SUBJECT: 10 CFR 2.206 Petition on Apparent Violation of 10 CFR 50.9

On behalf of Three Mile Island Alert ("TMI Alert"), I submit this petition pursuant to §2.206 in Title 10 of the Code of Federal Regulations (hereafter "10 CFR"). We petition the Nuclear Regulatory Commission ("NRC") to take enforcement action on regulation §50.59 in 10 CFR "Changes, tests and experiments" regarding an apparent design and manufacturing defect with the replacement steam generators at the Three Mile Island Unit 1 Nuclear Station (TMI) licensed to Exelon Generation Company LLC, the owner - Docket No. 50-289. The defects caused some of the steam tubes to become damaged by striking or rubbing against each other.

Exelon's graph¹³ on steam tube deflection + extended extrapolation

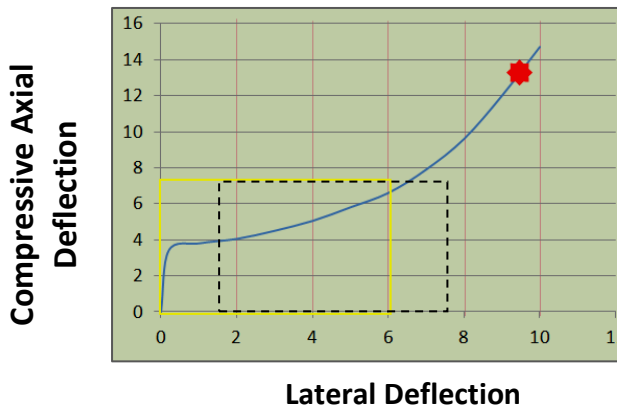
Exelon's original graph is bound by the dotted lines on the lower left. The graph has been extended here by TMI Alert to extrapolate how great the lateral deflection or bowing would be if temperatures rose to 1100°F degrees as marked by the red star. Normal operating temperatures are ~ 550°F. An analysis is needed to determine the accuracy of this projection because the actual value is not known.
